Notice of Allowability	Application No.	Applicant(s)	
	10/750,388	NETZEL ET AL.	
	Examiner	Art Unit	
	Mark T. Le	3617

EXAMINER'S AMENDMENT

Examiner's Proposed Drawing Correction

Fig. 4

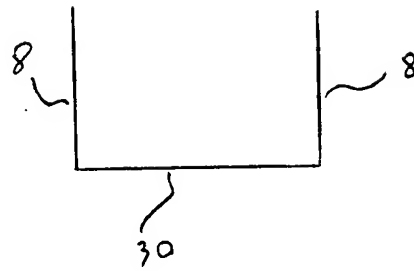
The proposed new drawings, Figures 4 and 5, filed on April 17, 2006, are not approved for entry because they are not fully supported by the originally filed disclosure. On the other hand, the examiner has provided an Examiner's Proposed Drawing Correction, including new Figure 4, which is considered to resolve the remaining objection to the instant drawings with respect to the features recited in instant claim 15. **Formal drawing is now required.**

-- connection includes, on both sides of the short circuiting device, closing levers connected via a connecting element so as to form a handgrip. --.

-- [0039.1] FIGURE 4 is a schematic representation of a handgrip in connection with closing levers. --.

-- Figure 4 shows a schematic in which connecting element 30, forming a handgrip, is connected to closing levers 8 located on both sides of the short circuiting device. --.

Appl. No. 10/750,388
Reply to Office action of Jan. 11, 2006
New Sheet

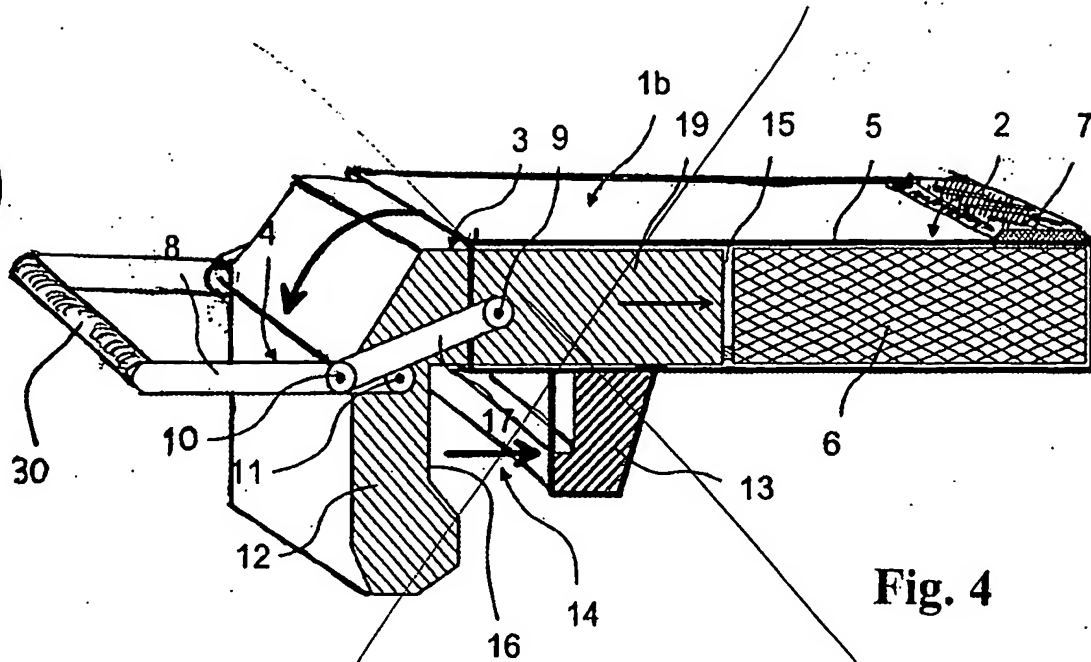
Entry
not
approved
5/16/06
